A66 Northern Trans-Pennine Project

7.40 Applicant's Response to Deadline 6 Submissions

**7.40 APPLICANT'S RESPONSE TO DEADLINE 6
SUBMISSIONS**

Deadline:	Deadline 7
Planning Inspectorate Scheme Reference	TR010062
Application Document Reference	NH/EX/7.40
Author:	A66 Northern Trans-Pennine Project, Project Team, National Highways

Drawing Title
**M6 Junction 40
Typical Sections
Sheet 1 of 1**

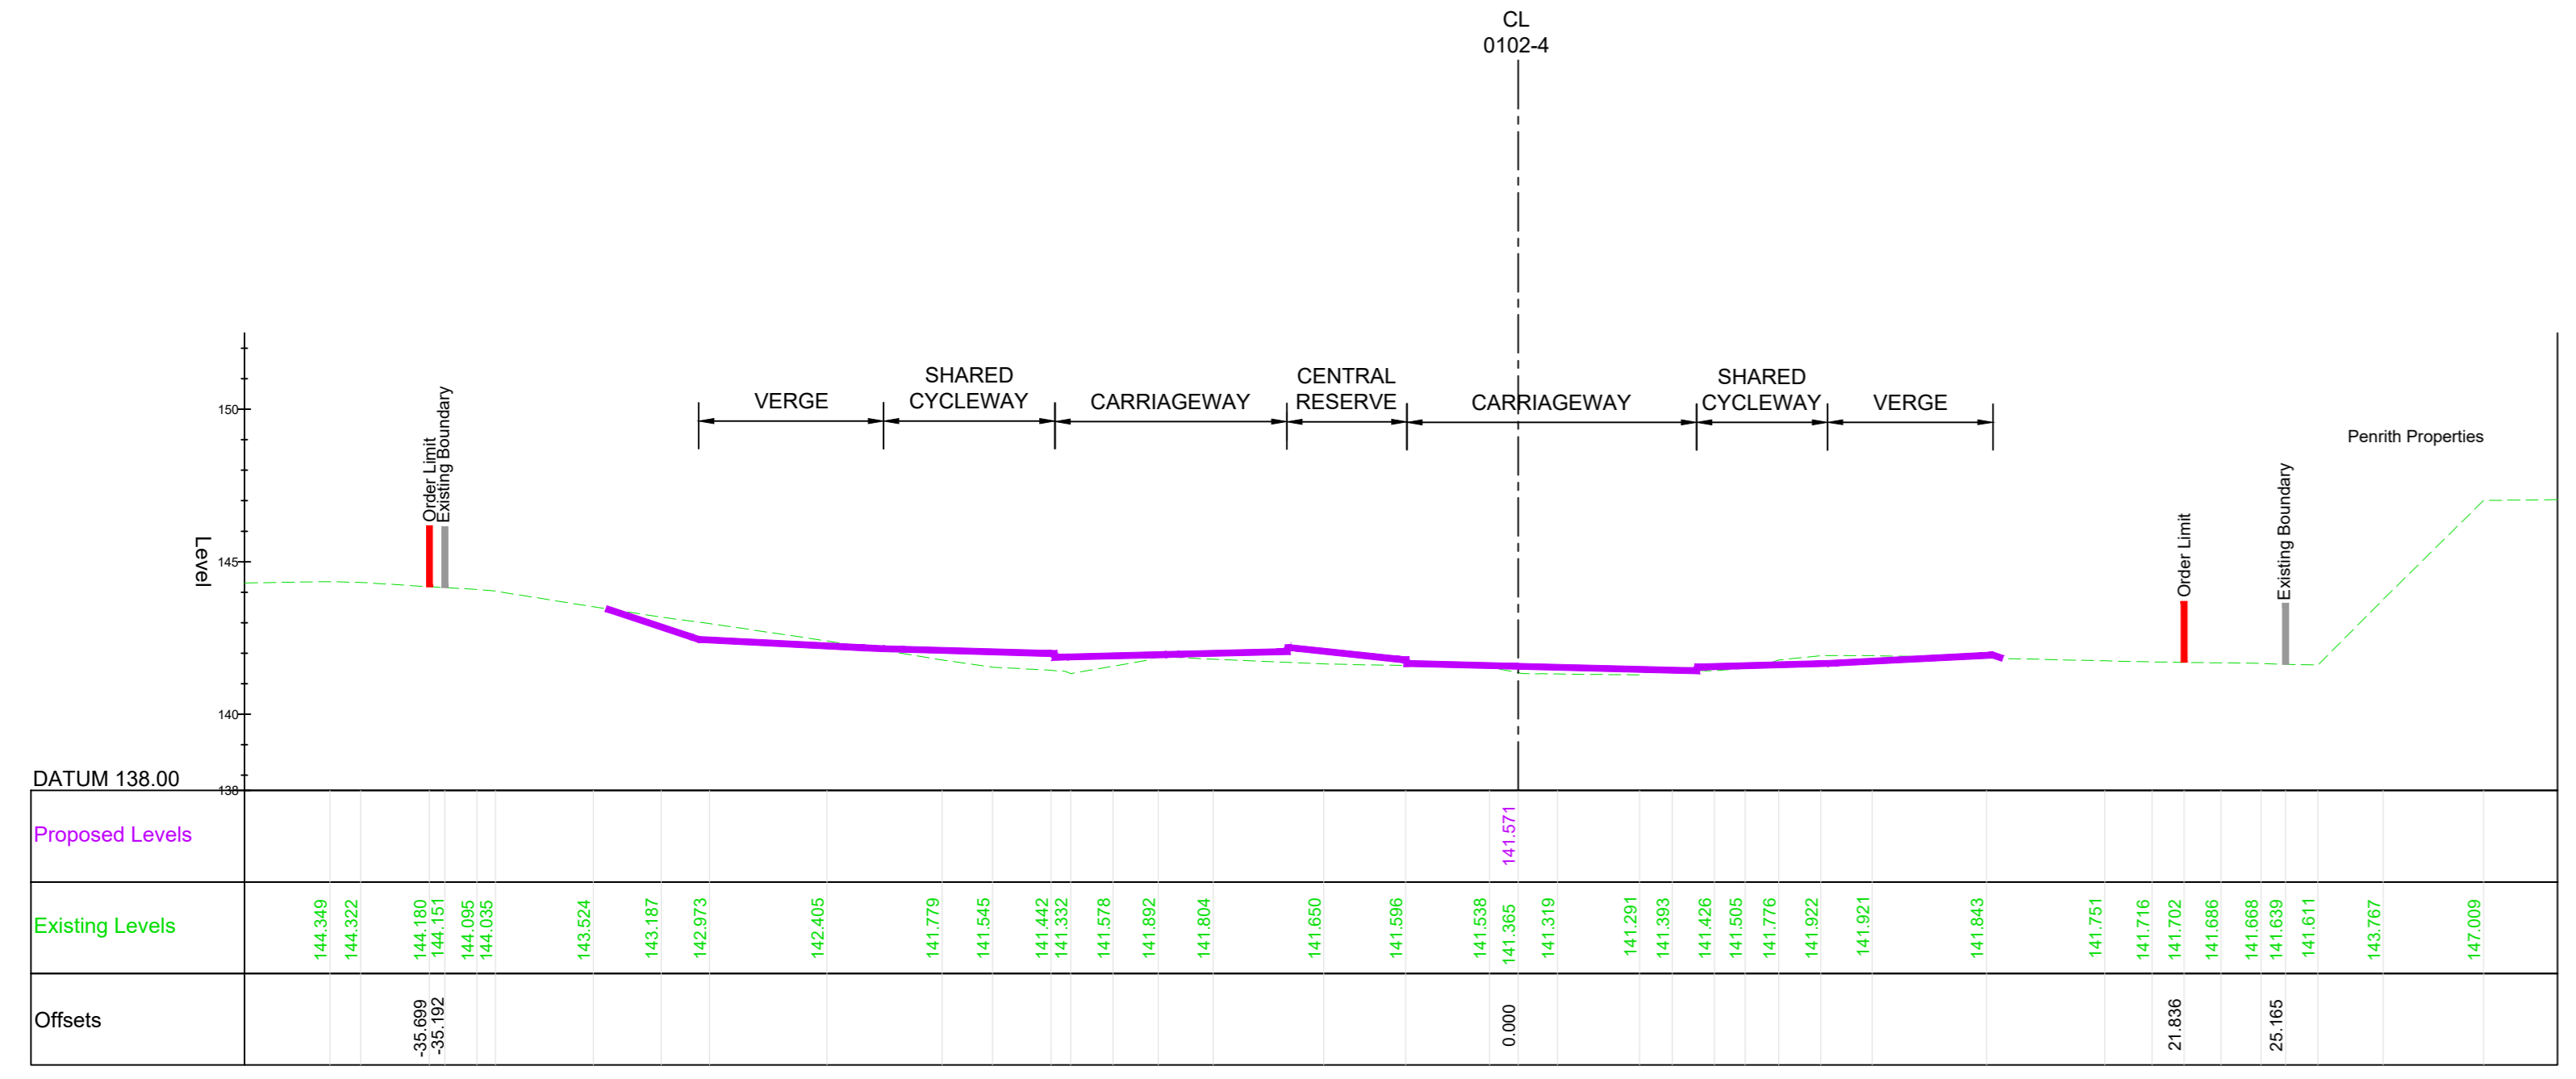
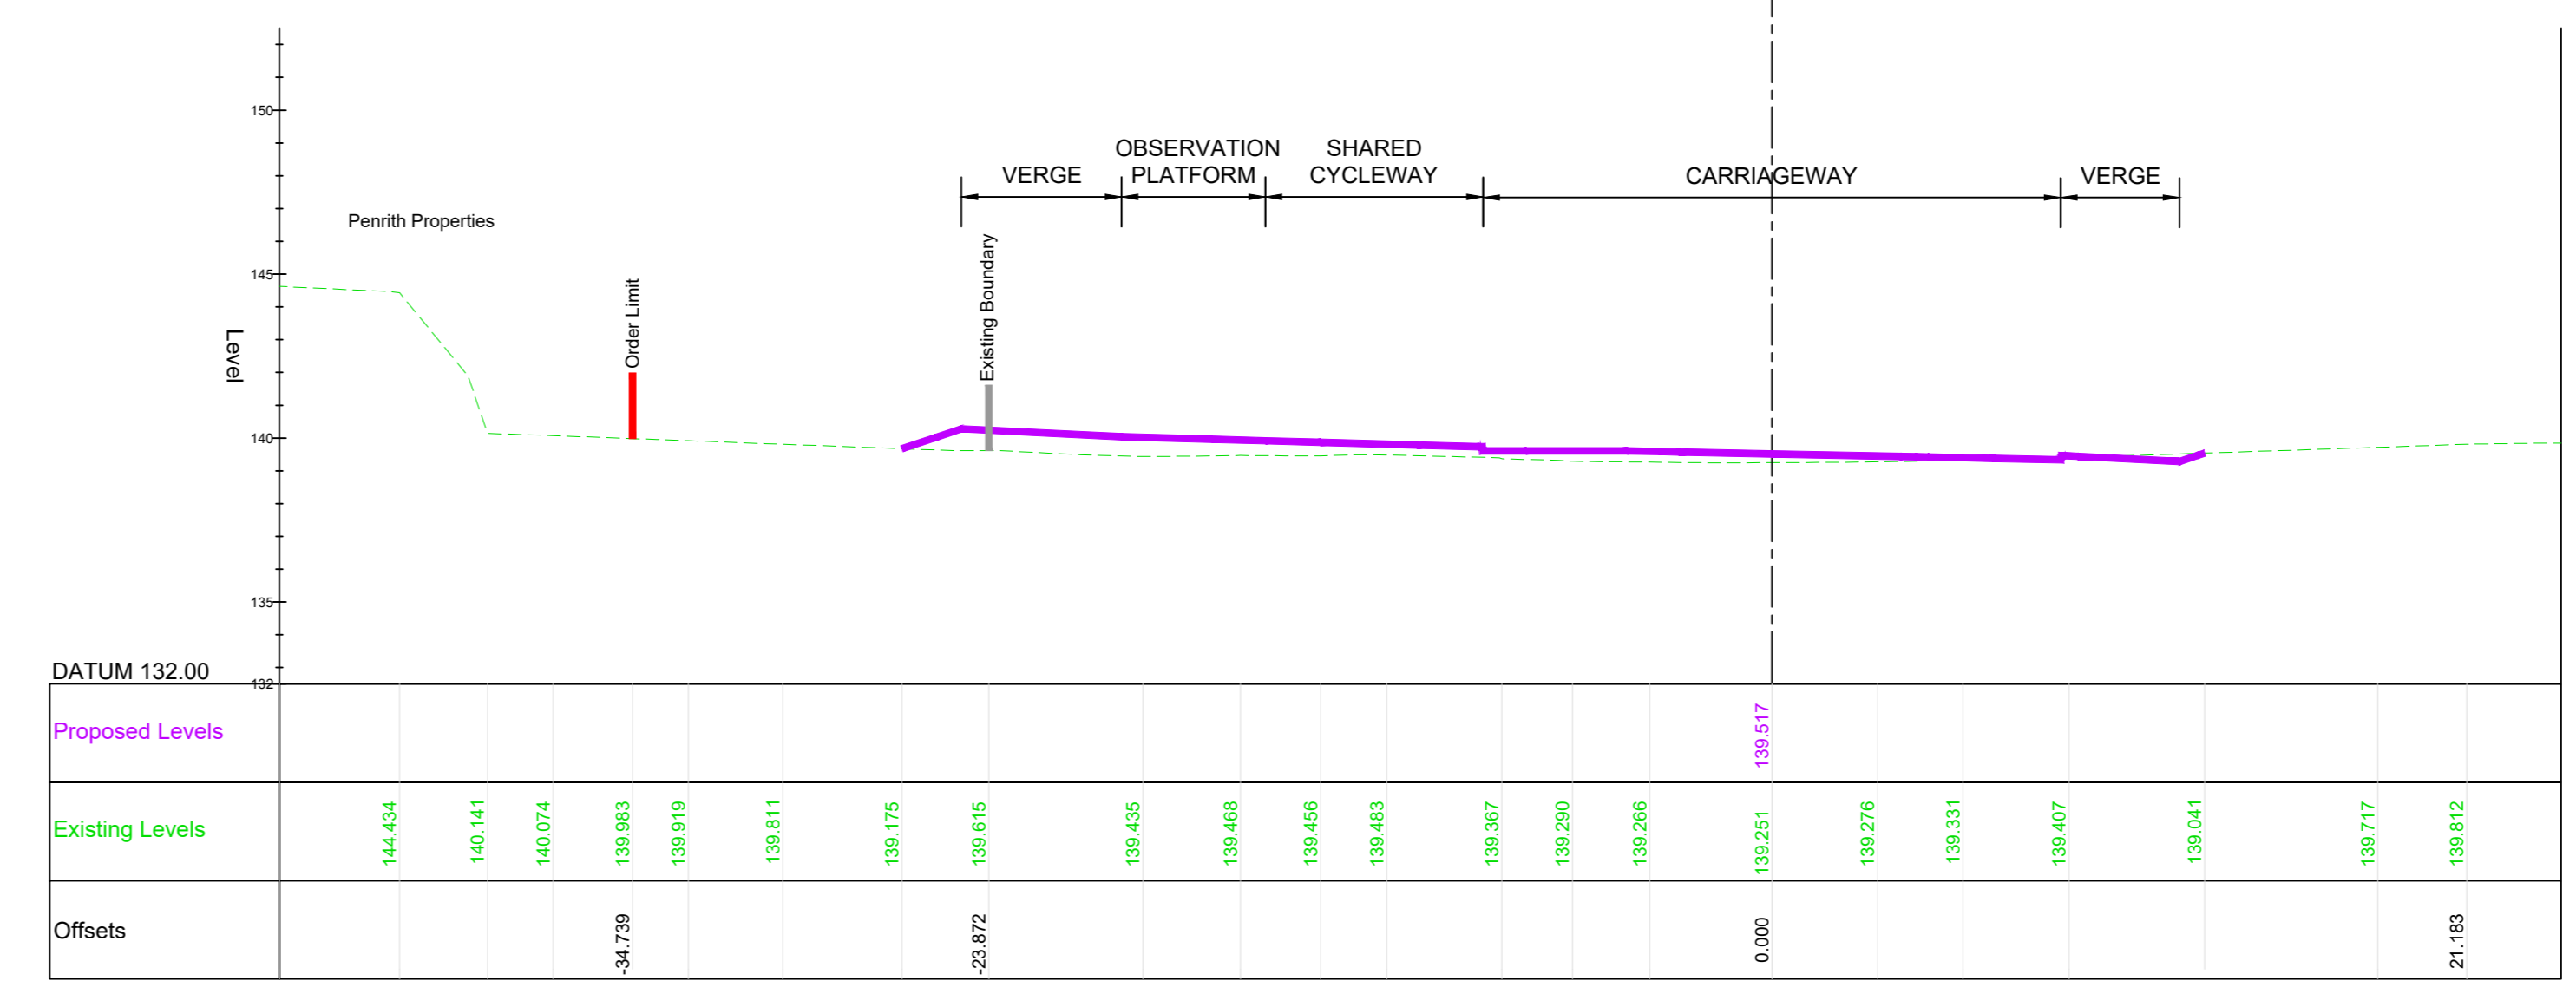
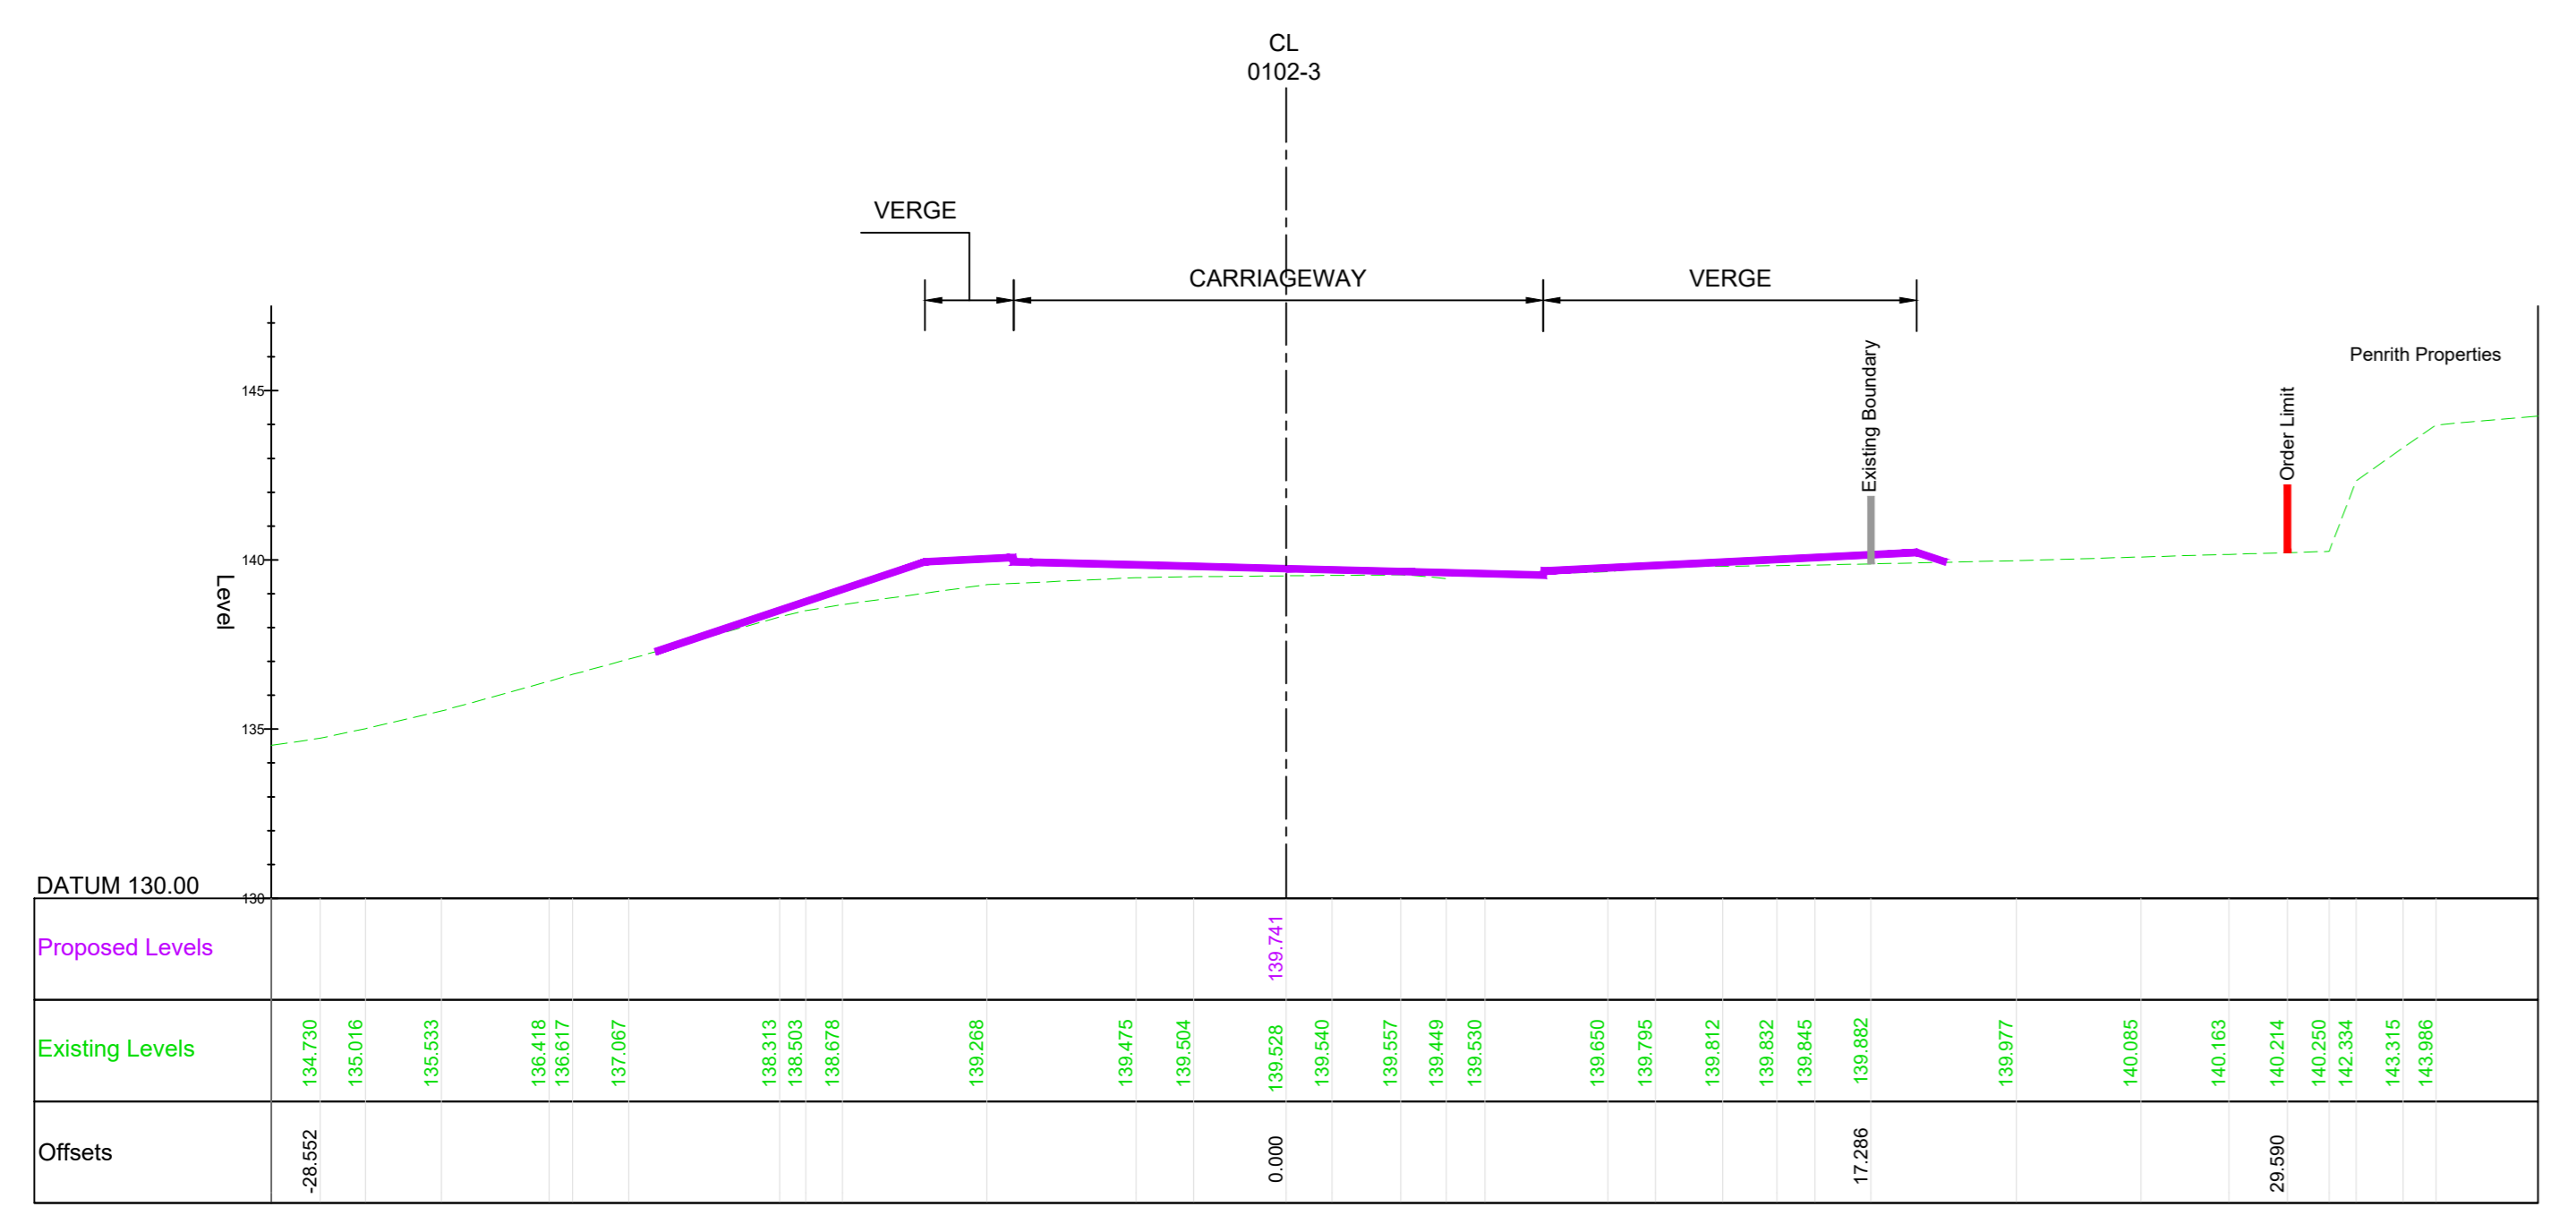
Examination Library Reference	Interested Party and Title of Submission	Issues Raised	Applicant's Response
		<p>the Examining Authority the Applicant presented the cross section at CH9840 which relates to Works 0102-1C as demonstrating the need for acquiring the land. Contrary to the assertion made by the Applicant these works do not adjoin plot 0102-01-20 (which is adjoined by 0102-1B, 0102-3 and 0102-4) and in presenting CH9840 in this context the Applicant is being misleading</p> <p>In relation to the proposed Road alterations (1a-d at pages 4-5) detailed points made on the labelling of drawings and details shown on individual work areas.</p> <p>There is no compelling reason to acquire PPL's land to accommodate the proposed levels changes (page 5) In responses to representations the Applicant makes no specific reference to the land being required for alteration to carriage way widths in these locations.</p> <p>There is no compelling reason to acquire PPL's land for road widening.</p> <p>2. Non-Motorised user facilities (Page 5) The Applicant has confirmed that a 6.5m strip containing the hard standing (1.5 m) Footway (2m) and Cycleway (3m) is required for non-motorised users. As demonstrated in document 7.30 Appendix G the available land within National Highways existing ownership adjoining 0101-01-20 is sufficient to accommodate the non-motorised user facilities without requiring additional land.</p> <p>3. Landscaping and Reprofilng (page 6) If narrowly interpreted to support landscaping and reprofiling for the purpose of the delivery and maintenance of the A66 improvements, there is sufficient land within the National Highways existing ownership to accommodate any necessary landscaping and reprofiling for the delivery of the A66 enhancements.</p>	<p>appropriate consideration of the land required for sight lines and to safely construct the works.</p> <p>The Applicant prepared a number of typical cross sections as part of the submitted DCO application. The cross section at CH9840 was the closest to the Applicant's land. The Applicant has since provided additional sections as described in the response to the issues raised (re lack of drawings, point 3 above) as set out above.</p> <p>Carriageway and verge widening will result in a change to levels. This will result in earthworks to accommodate this change and space to safely construct the earthworks, will be required.</p> <p>In addition to the NMU facilities, the land identified also includes appropriate space to accommodate widening of the carriageway, sight lines around the bend, earthworks to facilitate changes in levels, fencing and working space to safely construct the works.</p> <p>As the Applicant is widening the carriageway, reprofiling and associated landscaping will be required when constructing the earthworks to facilitate the change in levels.</p> <p>The Applicant considers the points under Landscaping and Reprofilng have been addressed in REP2-015 [Document Reference 7.6, REP2-015], REP5-023 [Document Reference 7.29, REP5-023] and REP6-021 [Document Reference 7.35, REP6-021].</p> <p>For the purposes of the DCO application, this land is required permanently to protect the ability of the Applicant to construct the Scheme safely and to the appropriate standards.</p>
